**LEVY NUCLEAR PLANT, UNITS 1 AND 2
DOCKET NOS. 52-029 AND 52-030
RESPONSE TO REQUEST FOR ADDITIONAL INFORMATION LETTER NO. 094 RELATED TO
PROBABLE MAXIMUM TSUNAMI FLOODING**

**Levy Nuclear Plant Units 1 and 2
Response to NRC Request for Additional Information Letter No. 094 Related to
SRP Section 2.4.6 for the Combined License Application, dated October 4, 2010**

NRC RAI NUMBER: 02.04.06-16

Landward Topographic Profile from
 Gulf of Mexico to LNP Site
 Attachment RAI 2.4.6-16A
 FIGURE 2.4.6-230

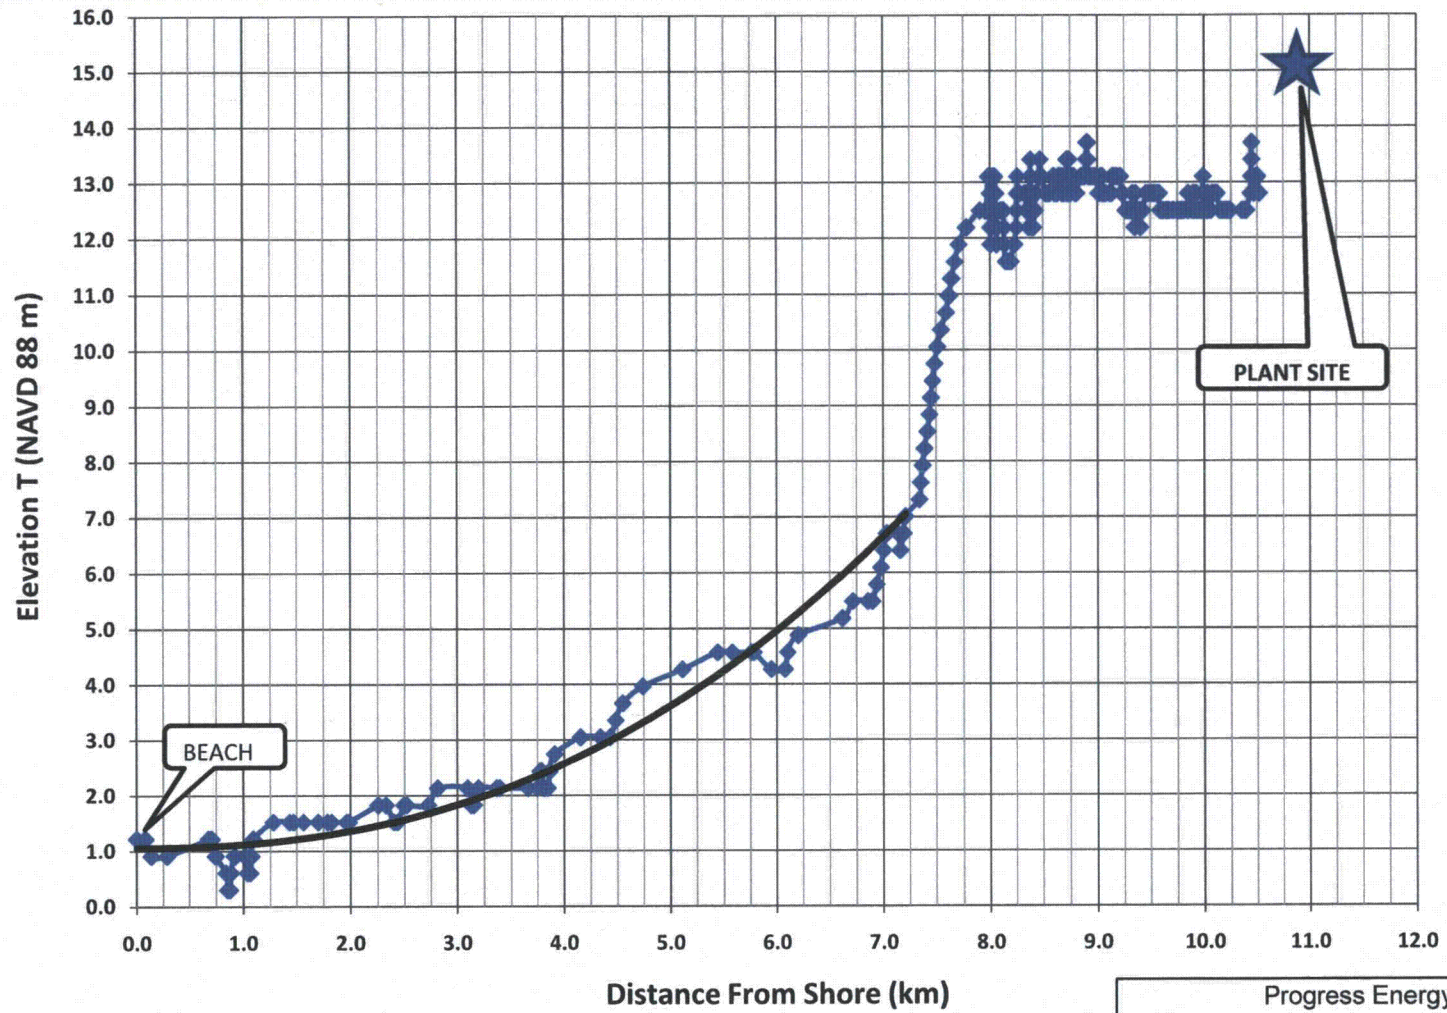
- 3) In reference to Progress Energy's response to RAI 02.04.06-15 (25 March 2010, NPD-NRC-2010-025, L0696), the PMT runup (21.4 m) given in Table 1 appears to be inconsistent with the accompanying inundation distance. It is noted that runup is defined as the ground elevation at the location of maximum tsunami inundation, which is consistent with the depiction given in Figure ATTACHMENT 02.04.06-15A. As can be found from topographic maps, the ground elevation at a distance of 1.2 miles from the shoreline in the direction of the Levy County site is approximately 1m. The 21 m topographic elevation is well inland of the Levy County site. It would not be expected that two separate equations are needed to find the runup and the inundation distance; calculation of either one, used in conjunction with topographic maps, provides the other value.

Please provide clarification on these values (η and X in Table 1), including which of the two values should be used to define the PMT, and if the variable definitions as given in Figure ATTACHMENT 02.04.06-15A are correct. In Table 1 provided in the response, please provide the geographic location (lat, long) corresponding to the location at the given distance R from the source, as well as the depth at that location, since it is needed to determine the runup elevation. Please present all equations used, including a discussion of assumptions inherent in these equations and the associated conservatism, and the procedure to calculate the provided values. Please provide all input data sources, calculation packages, and associated modeling input files.

Note that the procedure for estimating run-in distance has been modified to eliminate the use of an average slope ($SIN\theta$) in the equation. The new approach uses an average slope determined directly from the more detailed landscape profile, shown in Attachment RAI 02.04.06-16A. For tsunamis with different run-in distances, the average slope for that particular scenario is applied and that can only be determined by using an iterative procedure. This will be clear by reviewing the proposed revisions to FSAR Subsection 2.4.6.6.3.5 provided in Attachment RAI 02.04.06-16C.

Because the landscape slope profile can be nonlinear, an iterative solution is required to solve for the run-in distance. To use Equation 2.4.6-20, start at $X_{max}=X_0$ and move inland using the local land profile to evaluate the left hand side until it first equals the right hand side. That X_{max} would be the run-in distance and $T(X_{max})$ would be the run-in elevation.
